REFERENCE NO - 20/502770/FULL		
APPLICATION PROPOSAL Erection of single storey side extension, part single storey part two storey rear extension, new upper floor, together with external alterations and change of use of commercial to residential to form 10 No. residential units.		
ADDRESS Holman House, Station Road, Staplehurst, TN12 0QQ.		
RECOMMENDATION Grant permission subject to updated conditions.		
SUMMARY OF REASONS FOR RECOMMENDATION The proposal represents sustainable development within the built up area. Whilst a net increase over the previous approval for 7 units, it is considered that the proposal represents good quality design and will provide acceptable living conditions for future occupiers and will not adversely impact on the amenity of neighbours. There are no highways, or other technical or environmental objections.		
REASON FOR REFERRAL TO COMMITTEE Contrary to the views of Staplehurst Parish Council and Ward Member request.

WARD Staplehurst	PARISH/TOWN COUNCIL Staplehurst	APPLICANT Arrant Land Ltd AGENT Blink Architecture
TARGET DECISION DATE 05/10/20		PUBLICITY EXPIRY DATE 30/07/20
UPDATE FOLLOWING DEFERRAL This application was deferred at the Planning Committe

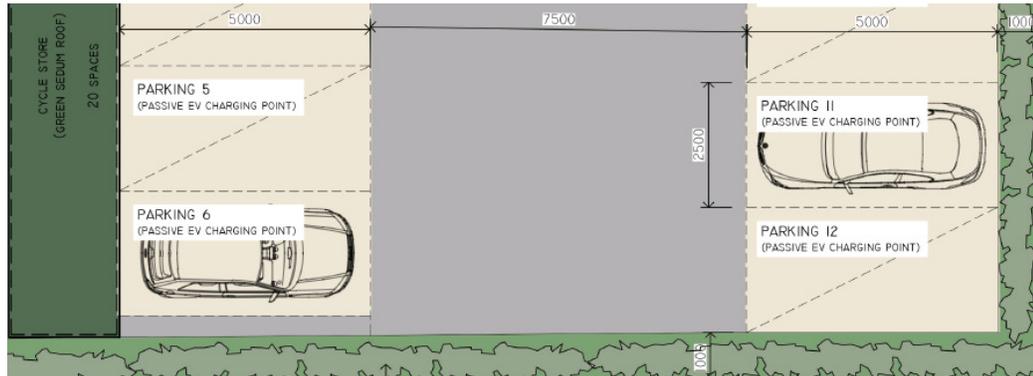
- 1.03 The applicant has subsequently confirmed that all ten of the proposed parking bays (including visitor bays) will be installed with passive EV charging capability and these are all now annotated on the plans, as demonstrated below.

- 1.04 Officers consider the passive provision to all bays is preferable as this would allow all residents in time to install charging devices with no associated infrastructure costs as and when the need arises. However, we would suggest the additional obligation that two charging posts are installed in the initial instance in order to provide immediate capacity and a visual presence. Condition 5 below is modified from the original report to require that these are installed prior to occupation.
- 1.05 With regard to renewables, the Applicant has confirmed that a PV array will be located on the roof of the rear wing. Amended condition 4 will secure its specification, installation, retention and maintenance.

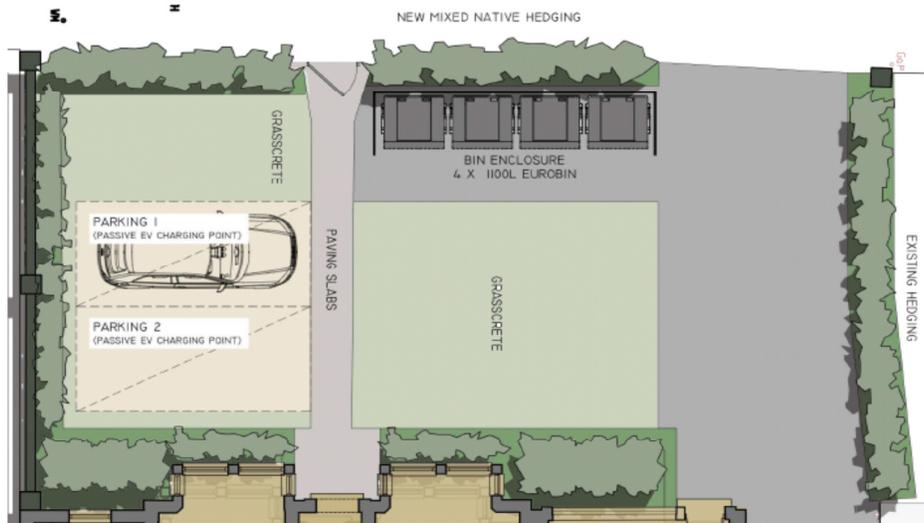
- 1.06 With regard to the existing front hedge, the Applicant confirms that the existing hedge is predominantly non-native and in poor quality, offering very limited habitat potential; but, that, in lieu of the previously proposed wall, it will be replaced where necessary with native hedgerow on three sides of the front forecourt. The side hedgerow along the driveway will be retained and enhanced where necessary.

- 1.18 Objectors raised concerns regarding the potential for refuse bins to obstruct the pavement. The proposed refuse storage arrangements are shown on the image under paragraph 1.06 above Plan P06B). As a communal development, it is not necessary for residents to place bins out for collection, however, they do have to be accessible for operatives. They are sited immediately adjacent to the access and well within the carry distances stipulated by the Council's refuse team. As such, it is not necessary for them to be placed on either the footway or driveway and as such, pedestrian movements will not be hindered.

- 1.07 Officers consider this an appropriate response to existing conditions which will result in a material net improvement to the site frontage.

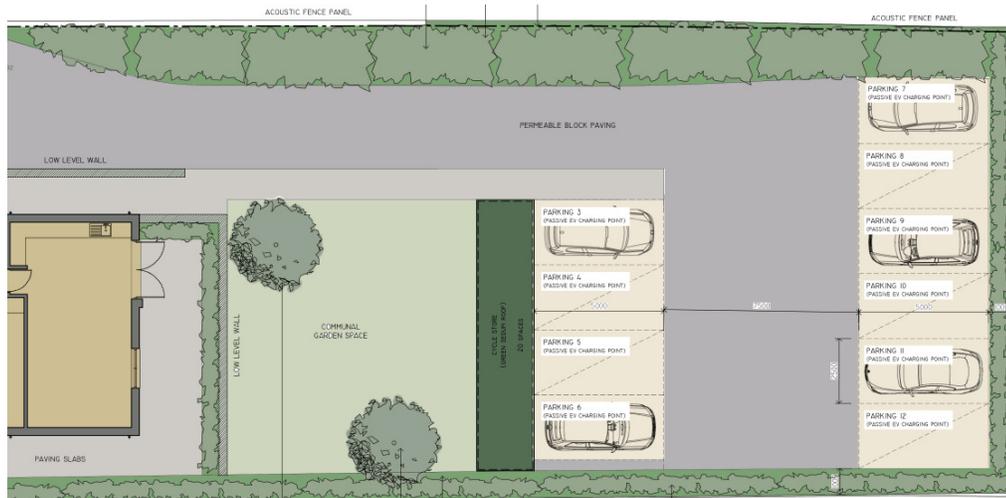
- 1.08 To the rear of the site, adjacent to The Yews, a new hedgerow is proposed. This will vary in depth between 1.8 and 2.5 metres and is circa 38metres in length.

- 1.09 A narrower hedgerow margin, circa 1m in depth will extend around the remainder of the site and extends to circa 60metres in length. The landscape officer has recommended species for the margins, which will include native planting, supplemented by wildlife friendly ornamentals / evergreens such as Cornus Kelsey (dogwood), Skimmia (Rubella) and Danae (Poet’s Laurel). Within the communal garden two native trees are proposed to be Sorbus Aria (common whitebeam) and Prunus Avium Plena (native cherry).

- 1.11 Officers consider that the clarified details of the planting scheme demonstrate that an appropriate level of biodiversity opportunity can be achieved, which will represent a significant uplift when compared to the both the existing site and the previously approved scheme.

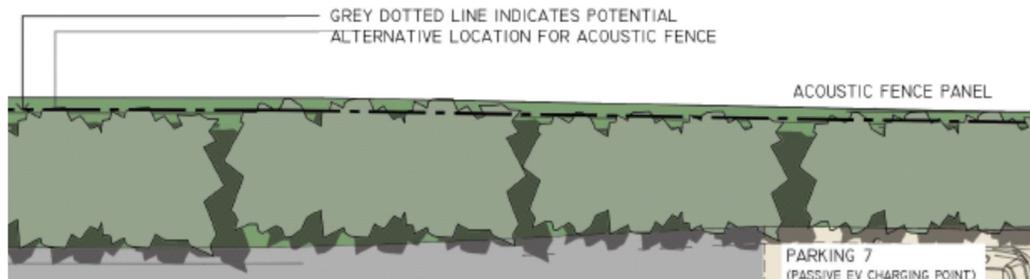
- 1.12 The immediate Neighbour raised concerns regarding the acoustic fence that is proposed along the boundary, indicating that on their deeds this appears as their fence. Whilst boundary issues are a private matter, as the installation of an acoustic fence is necessary in order to mitigate the impact of the scheme, it is important to ensure that this can be implemented should the Neighbour wish to retain their existing boundary fence. The Applicant has annotated the layout plan (P06B) to show that an acoustic fence could be installed inside the line of the existing boundary fence without compromising either the access arrangements or proposed landscaping.

- 1.13 Officers note that the dimension for fence posts for a typical acoustic system is similar to a domestic fence, at 120mm, and therefore consider that an acoustic fence could be inserted inside the existing fence line should the neighbour wish to see it retained and that the required mitigation could therefore be secured.

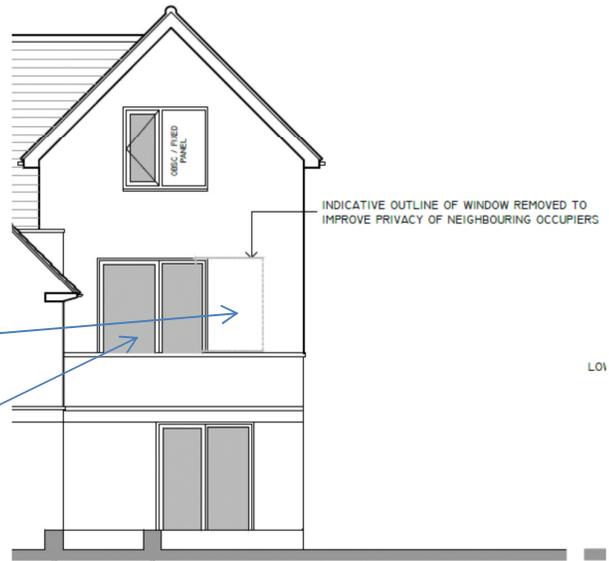
- 1.19 The Applicant has provided further information in response to this point, including an updated window scheme. Firstly, the Applicant has annotated the level of the parapet wall on the link block. This is denoted by the drawn line on this photo supplied by the neighbour. The Applicant highlights that the effect of the parapet wall is to screen windows increasingly as they cross the elevation.

- 1.20 It is understood that the closest window shown in the photograph served a bedroom when previously occupied; whilst in the permission for 7 units, this would become a living room.

1.21 Whilst re-planning the internal layout to improve consistency of flat sizes, the Applicant has proposed that this room be switched from a living room to a bedroom, thus reducing the propensity for an occupier to look out.

1.22 In addition, the Applicant now proposes that the closest first floor window be removed.....

.... and that, what is now a bedroom window, be relocated further away from the boundary.

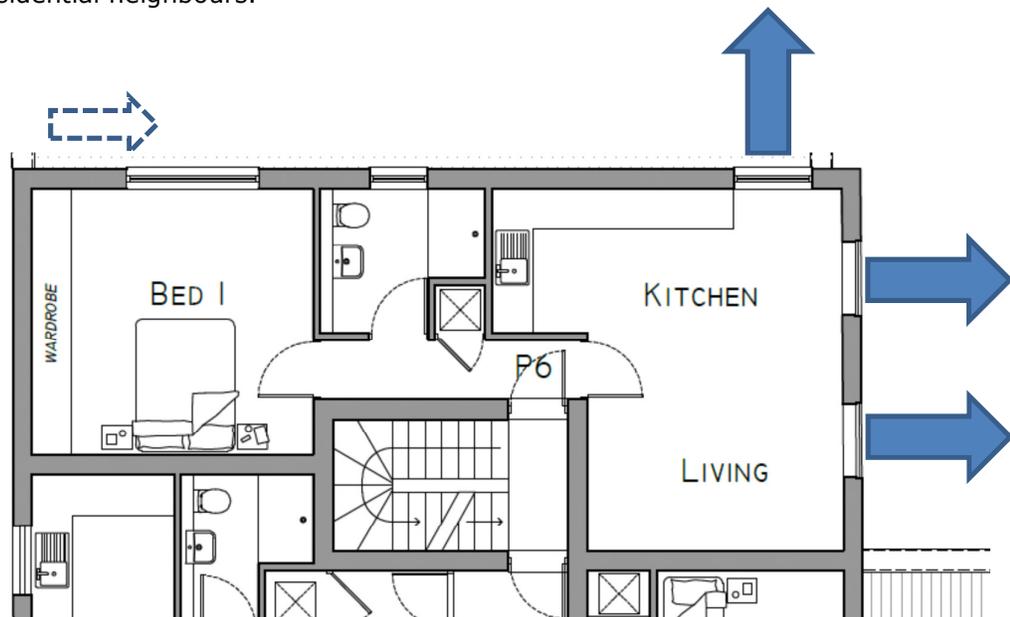
1.23 In Officers view this window would not lead to direct overlooking of the neighbour as its view is down its own garden. In addition, having regard to the fact that; in the previously approved permission there are two living room windows in this part of the elevation, and as the function of this room reverts to a bedroom with what is now a single window moved further away than currently exists; Officers consider that this latest update represents a material benefit when compared to either the existing situation or the approved fallback.

1.24 The principal living room windows to this apartment now look away from the residential neighbours.

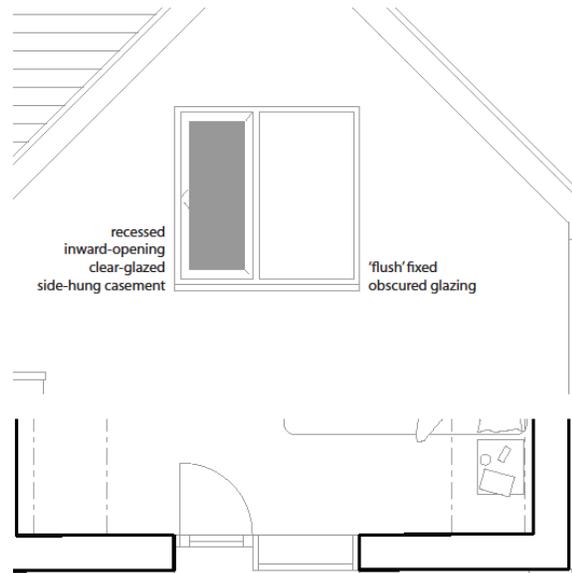
1.25 The Applicant has also proposed an amendment to the new second floor rear window. Again the internal layout is 'flipped' so that this room changes from living room/kitchen to a bedroom, thus, again the propensity for outlook is reduced.

1.26 That part of the window closest to the neighbour will be a fixed obscure pane; whilst the clear glazed opening part will be recessed, thus ensuring no unacceptable loss of privacy would occur.

1.27 Officers do not consider that this new window would result in any loss of privacy.
